5.2 Workshop 2

5.2 Workshop 2: Shared Amenity

RED HILL, WORKSHOP 2: DESIGN OPTIONS TESTING THE SHARED AMENITY

OPTION 1: SHARED AMENITY 280 dws.

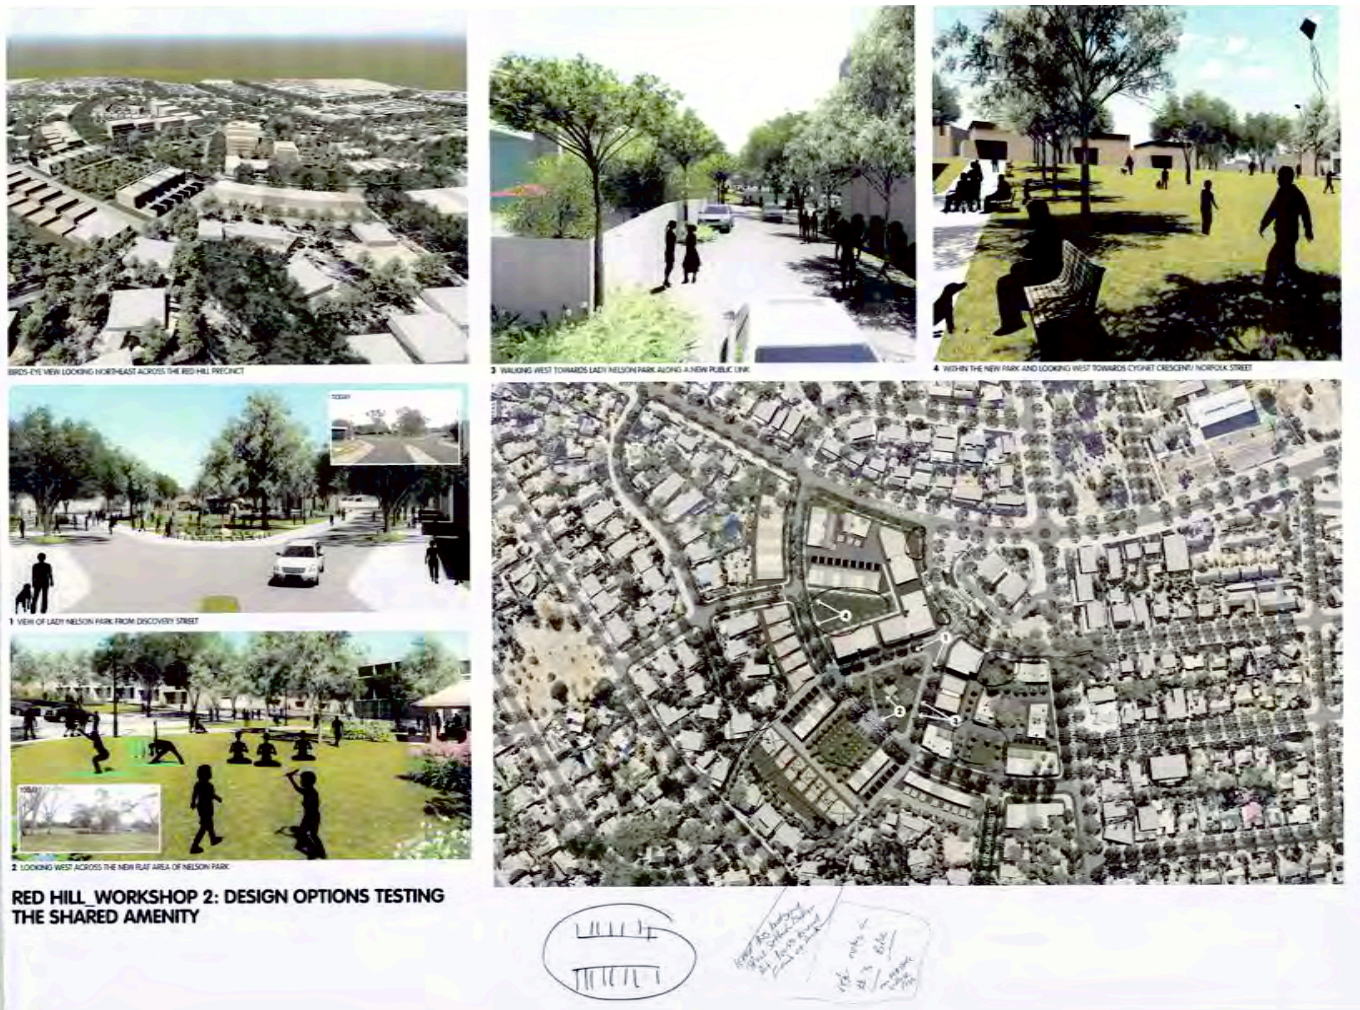
Key Improvements:

- Testing south-west area (top of hill) for views/aspect
- Widen laneways
- Traffic access in and out

no of dwellings ok
minus 2 (top sides of section 31)
better location of green spaces
broken up nicely

section 31 setbacks
esp. on the top sides
- only 2 storeys on the high ridge of section 31
- section 31 garages?
- lane treatment?
- La Prouse - Cygnet pedestrian breakthrough

less 4 storeys more green space

lights and laneways above Cygnet Cres

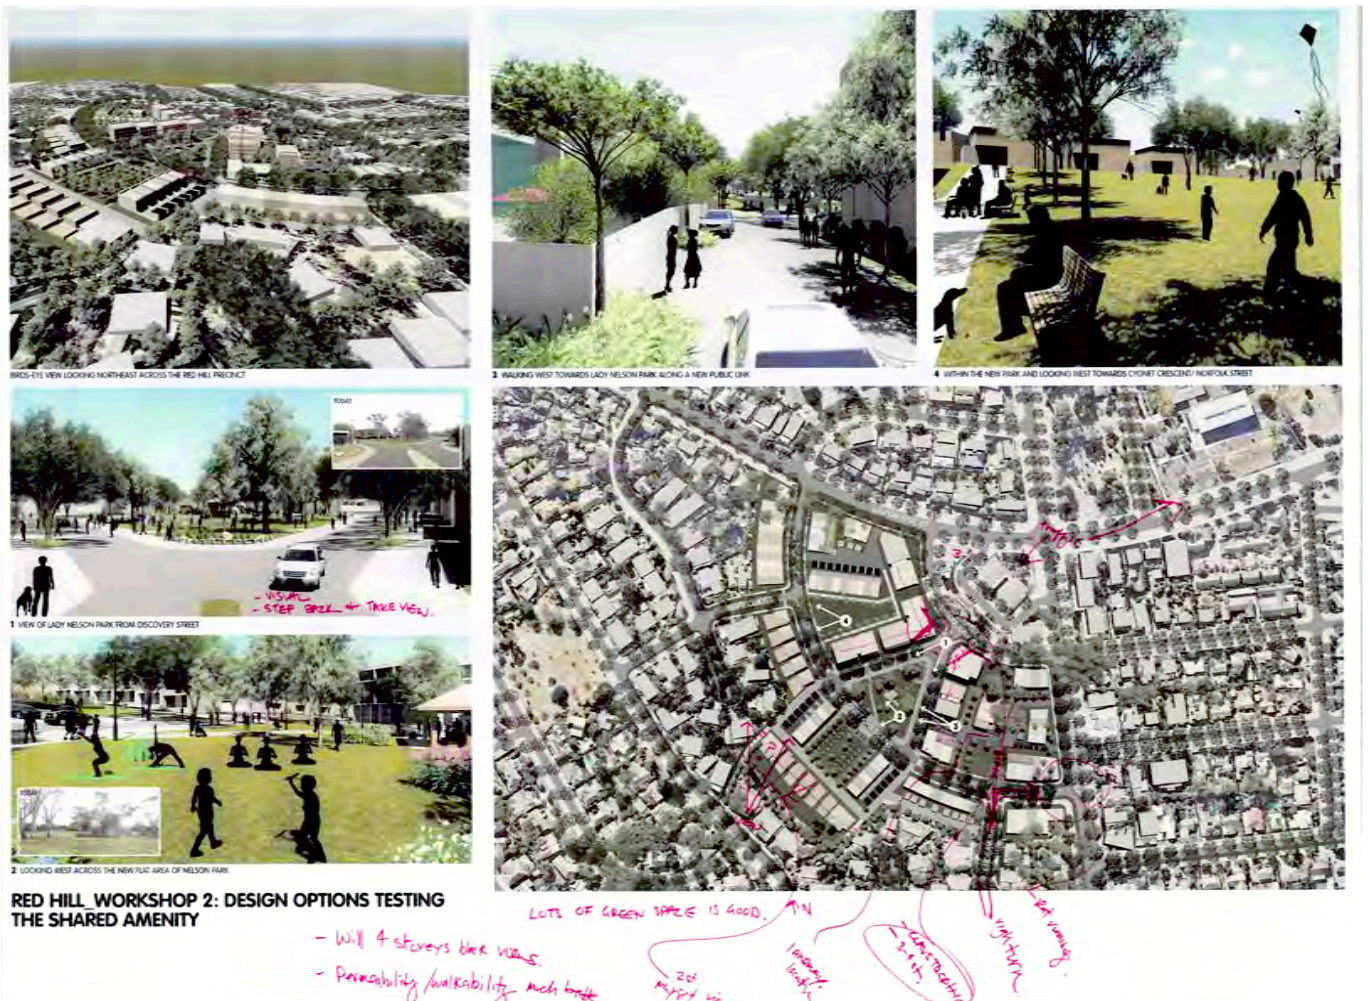
- Setbacks at Discovery Street - open up to allow view to park from shops
- Visitor parking
- 2-storey maximum on housing backing onto Beagle Street housing

OPTION 1: SHARED AMENITY	
<p>Views into parks</p> <p>Setback at rear - 2 stories</p>	
<p>Setbacks along Discovery St ↗ to prevent an enclosed area above shops.</p> <p>Near Beagle St. max 2 stories Set back from lane way</p> <p>Visitor Parking</p>	
<p>Access to Parks & throughfares.</p>	
<p>↘ Setback along Discovery St to open up view to park from shops.</p>

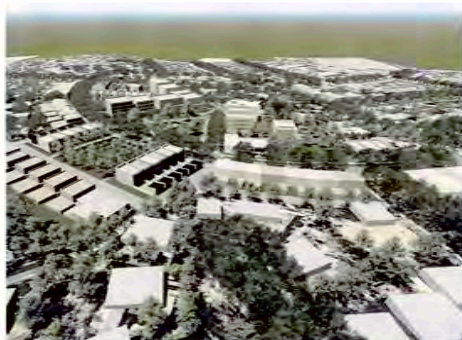
- Monaro Cres/Espreance St intersection

The parkland
The vistas onto the parkland. Small blocks
Amount of greenery
Buildings broken up →
mix of built form → subdivision possibilities
Water features
We like 280 max.

Take a storey off
the 4 storey dwellings
~~small blocks~~
No big, 3 storey dwellings with
little/no setback on top
section

Green spaces
+ height gradation from
the precinct edges

Honaro/Esperance
intersection needs
improvement - dangerous.
Exit marked ~~it~~ should be
a laneway,
not a roadway.

RED HILL WORKSHOP 2: DESIGN OPTIONS TESTING THE SHARED AMENITY

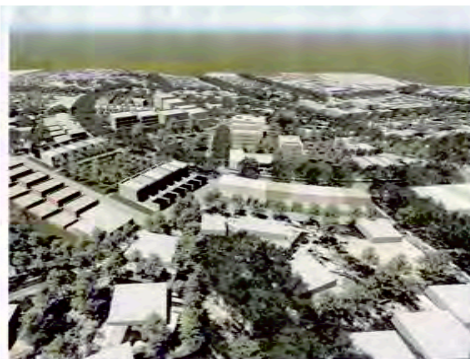
- Reduce number of dwellings

OPTION 1: SHARED AMENITY	FAMILY
<p>+ diverse.</p> <p>more permanant popn - community building - broken up blocks</p> <p>separation to bulk/built form single dwellings</p> <p>view retention.</p> <p>sympathetic to current built form</p> <p>seems more "broken up" - more greenspaces etc.</p> <p>Discourage car use around park.</p> <p>→ front loading parking on multi unit around park takes away from community space - rear loading preference.</p> <p>↳ option 2 also.</p>	<p>safety for movement</p> <p>kids</p> <p>traffic control.</p>
Green space	
# dwellings.

RED HILL WORKSHOP 2: DESIGN OPTIONS
THE SAVANNAH MODEL

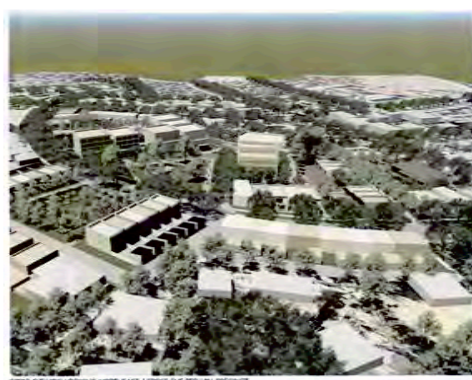
- Redirect traffic from Esperance Street

OPTION 2: SAVANNAH MODEL	
<p>Lane ways</p> <ul style="list-style-type: none"> - Continuing Norfolk + Endeavour through the development. <p>Deon Access for vehicles</p> <ul style="list-style-type: none"> - no bank of garages along La Perouse + Monaro. <p>Town space/Village Square</p> <p>Blocks (4 storey) broken up by park on S.W side</p>	
<p>New Beagle St max. 2 storeys & set back from the paths on each side</p> <p>Set backs along Discovery St.</p> <p>to prevent enclosed areas above shops.</p> <p>Visitor Parking.</p>	
<ul style="list-style-type: none"> - Continuation of Norfolk + Endeavour through development & Village Square Effect. 	
<p>That the restriction measures from Endeavour St.</p>

RED HILL WORKSHOP 2: DESIGN OPTIONS TESTING THE SAVANNAH MODEL

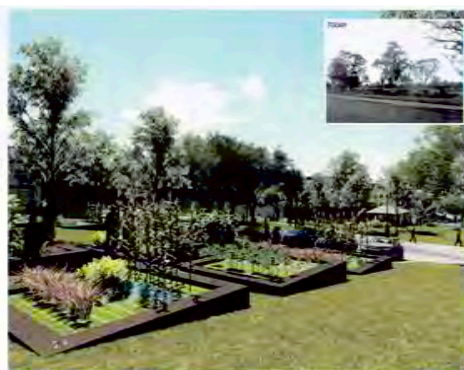
- Improved outcome for dwellings along site boundary

- Reduce number of laneways - safety issues

OPTION 2: SAVANNAH MODEL	FACTORY
<p>→ through linkages</p> <p>→ lower dwelling yield.</p> <p>→ La Perouse residents will be happier (fronting 3 storey product).</p>	
<p>traffic control. → tries to cater more for traffic in internal spaces - risk of rat running</p> <p>→ more built up area / less green - more hardspace.</p> <p>→ "University-ish" - campus like.</p> <p>→ hands safety of laneways - lighting</p> <p>→ park edge - footpath - sacrifices greenspace?</p> <p>→ lots of car intersections/access points.</p> <p>La Perouse / bandary.</p>	<p>but ambivalent towards them being streets - more pedestrian oriented.</p>

RED HILL WORKSHOP 2: DESIGN OPTIONS TESTING THE HILLSIDE VILLAGE

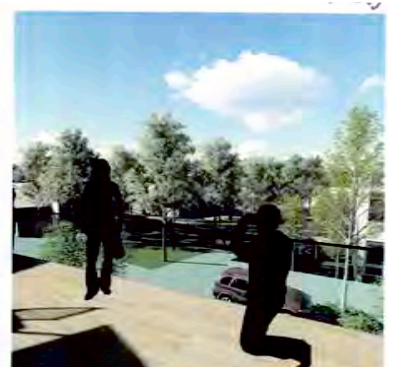
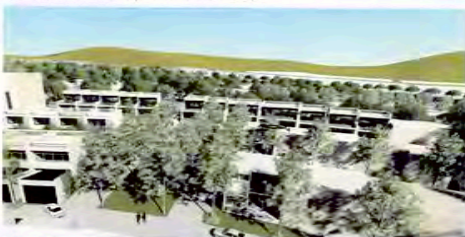
- Reduce amount of hard surface
- Increase greenery (street trees, greenspace, etc)
- Reduce number of access laneways

Level areas in the park.
Stepping down.
Max 250!
Small blocks.

Doesn't seem to be enough greenery.
Too much road.
The 4 storey dwellings go too far up the hill.

Terraces off Manaro could have half the amount of road frontage - extend blocks to front & back so one row have rear access & the others front access only.
